Agenda
Village of Arlington Heights
Design Commission
Community Room, 3rd Floor

Arlington Heights Village Hall
33 S. Arlington Heights Road
Arlington Heights, IL 60005
January 26, 2016
6:30 PM

**MINUTES OF
THE VILLAGE OF ARLINGTON HEIGHTS
DESIGN COMMISSION MEETING
HELD AT THE ARLINGTON HEIGHTS MUNICIPAL BUILDING
33 S. ARLINGTON HEIGHTS RD.
JANUARY 5, 2016**

BETH AND BRIAN TAVARES
817 S. CHESTNUT AVENUE, ARLINGTON HEIGHTS, IL 60005

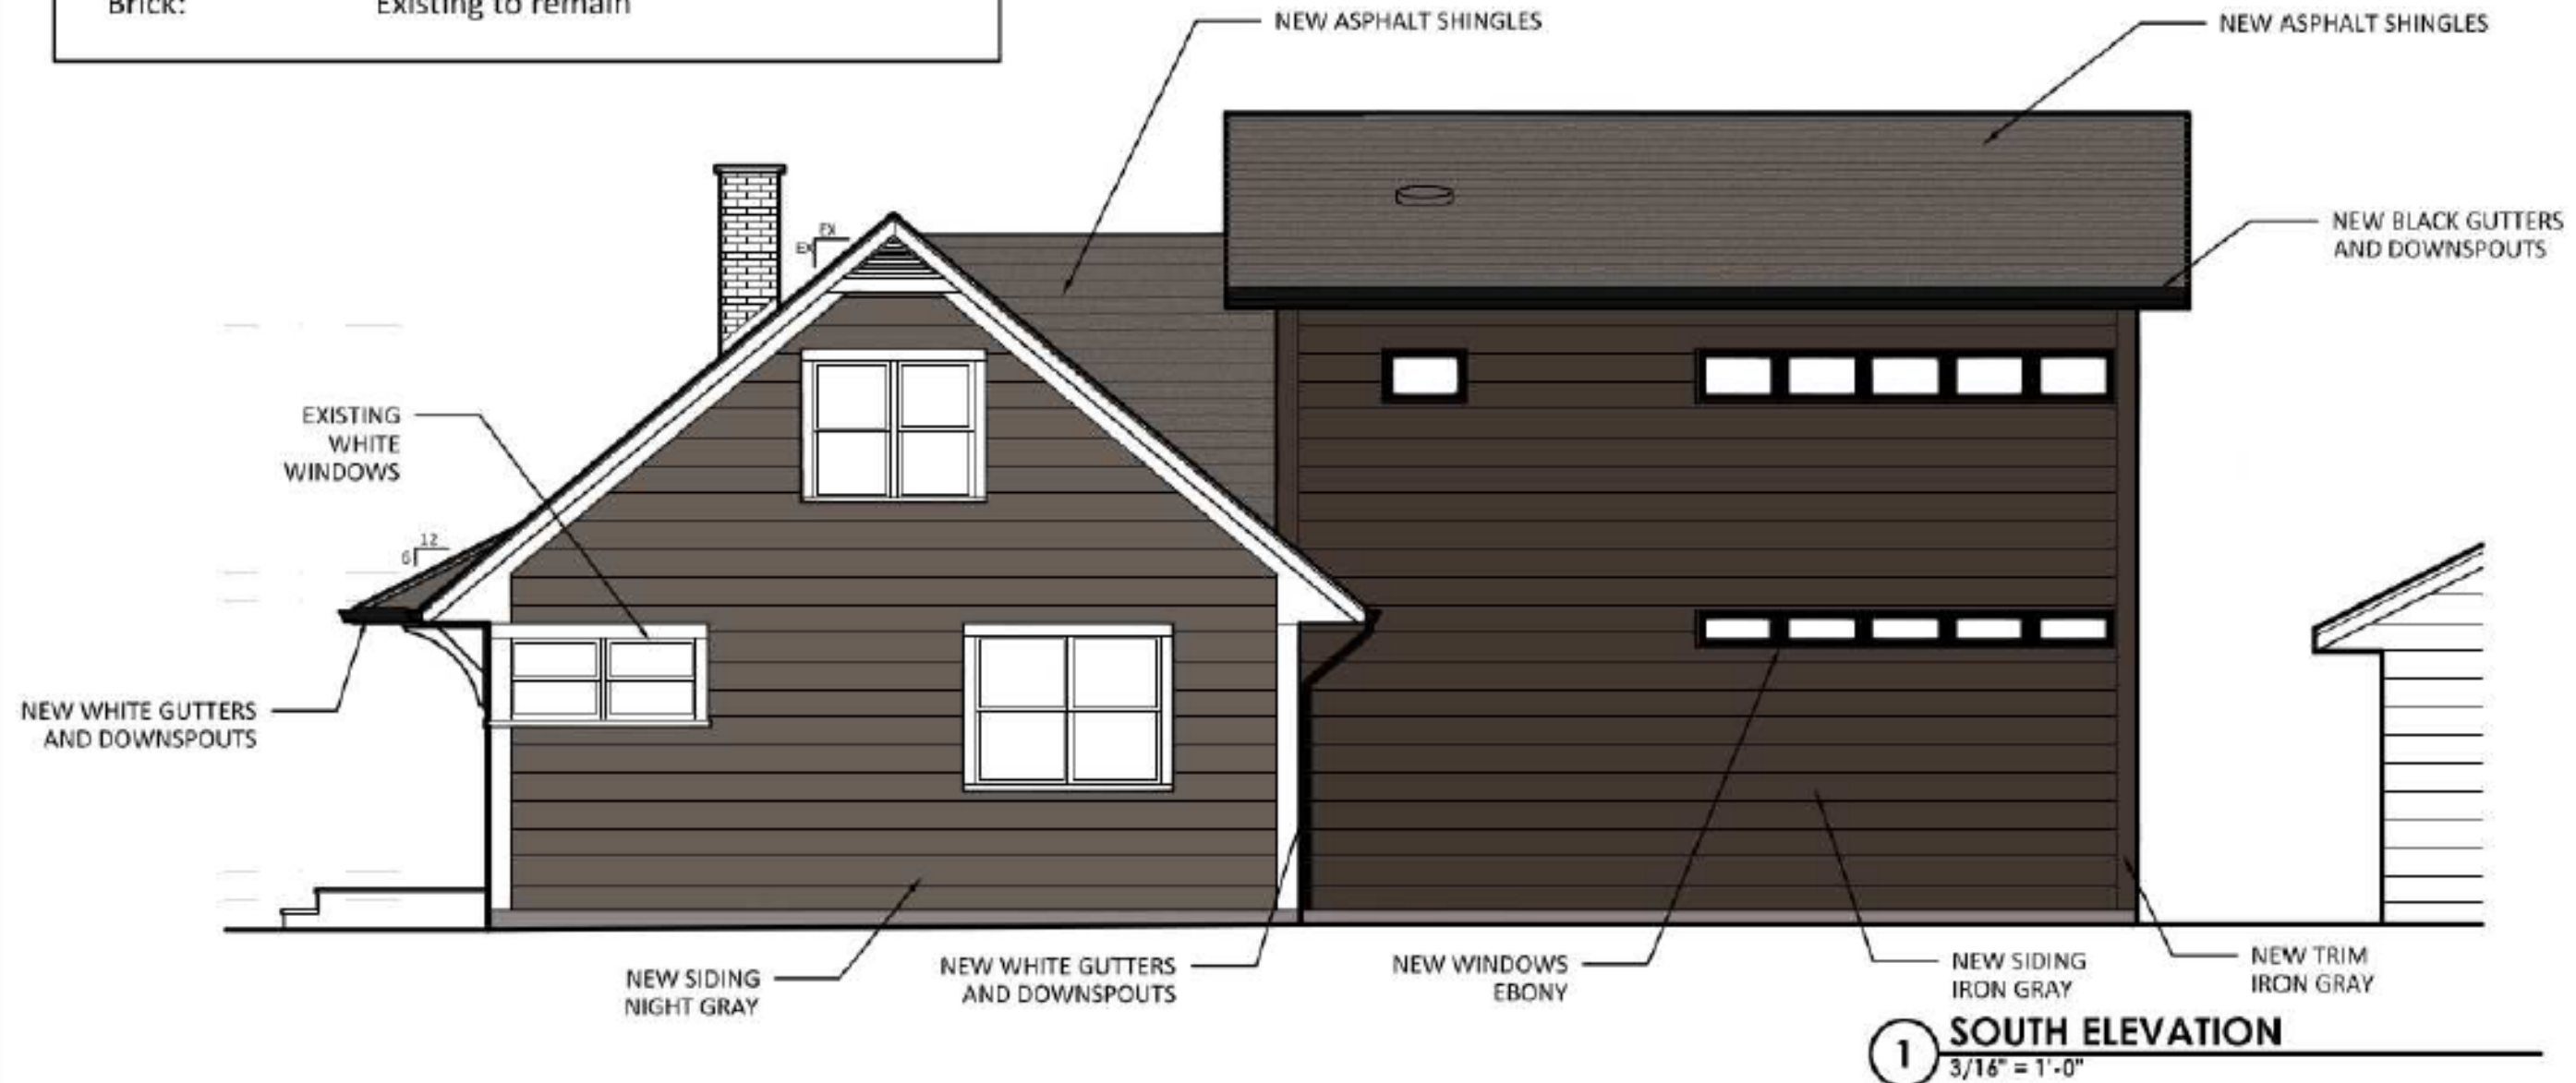
The existing neighborhood consists of a mix of traditional style single story, one-and-a-half story, and two story homes. The proposed two story addition is a modern design that is in contrast to the existing house. One of the goals of the Village's Single-Family Design Guidelines is that *"Building (additions) will reflect and improve the character of the site and the neighborhood upon which they are located. New additions will look like they belong and not dominate or change the character of the original building"*. The addition is proposed to have a bold, dark color scheme that is different than the existing part of the house, and the overall massing and form of the proposed addition does change the character of the original house.

However, the proposed addition will have very limited visibility from street, and will only be visible from the neighboring homes. The Design Commission should evaluate the appropriateness of the proposed modern style. For a more cohesive design, it is recommended that the material colors on the proposed addition be revised to match the existing portion of the house with white windows, night gray siding, white trim, and white gutters.

1. Revise the color scheme of the addition to match the house with white windows, night gray siding, white trim, and white gutters.
2. This review deals with architectural design only and should not be construed to be an approval of, or to have any other impact on, any other zoning and/or land use issues or decisions that stem from zoning, building, signage or any other reviews. In addition to the normal technical review, permit drawings will be reviewed for consistency with the Design Commission and any other Commission or Board approval conditions. It is the architect/homeowner/builder's responsibility to comply with the Design Commission approval and ensure that building permit plans comply with all zoning code, building permit and signage requirements.
3. Compliance with all applicable Federal, State, and Village codes, regulations and policies.

SITE PLAN

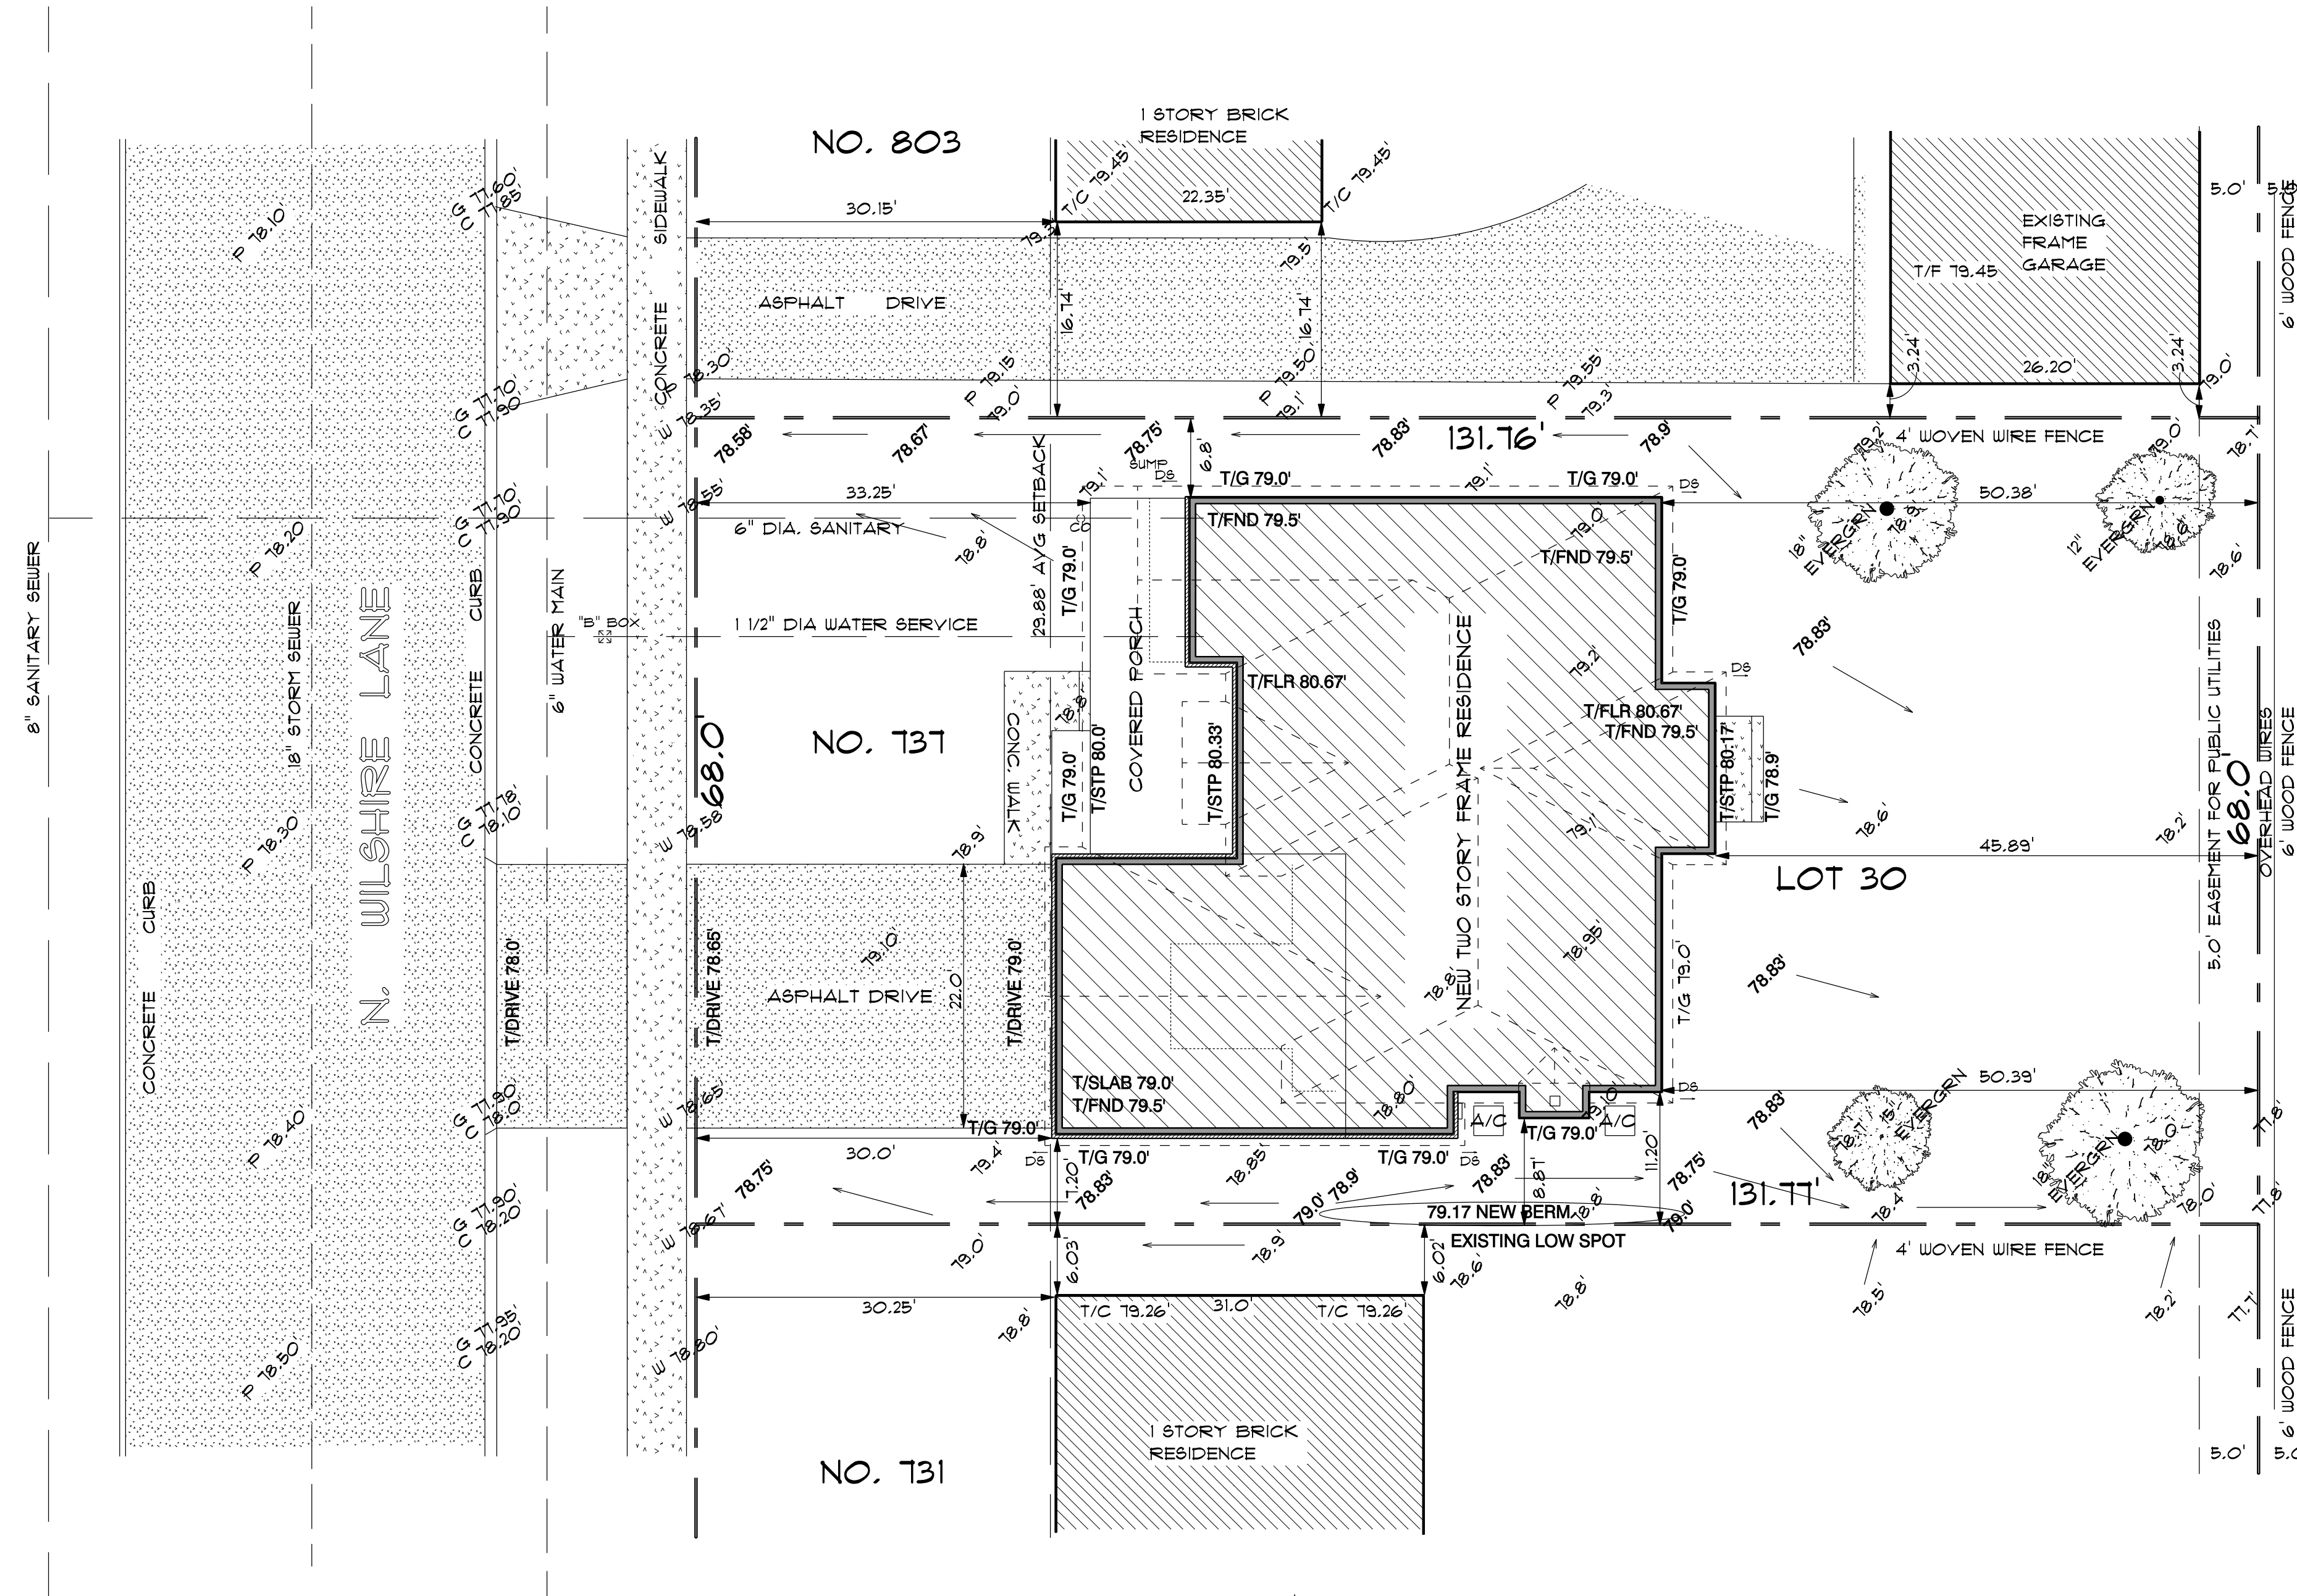
1. Consider hiping the front of the garage roof to omit the excess attic floor space, and including a small dormer to match the front elevation.
2. Change the horizontal siding to shake style siding on the upper floor of the side and rear elevations to match the front of the house.

3. Add decorative grilles to the windows on the side and rear elevations to match the front of the house.
4. This review deals with architectural design only and should not be construed to be an approval of, or to have any other impact on, any other zoning and/or land use issues or decisions that stem from zoning, building, signage or any other reviews. In addition to the normal technical review, permit drawings will be reviewed for consistency with the Design Commission and any other Commission or Board approval conditions. It is the architect/homeowner/builder's responsibility to comply with the Design Commission approval and ensure that building permit plans comply with all zoning code, building permit and signage requirements.
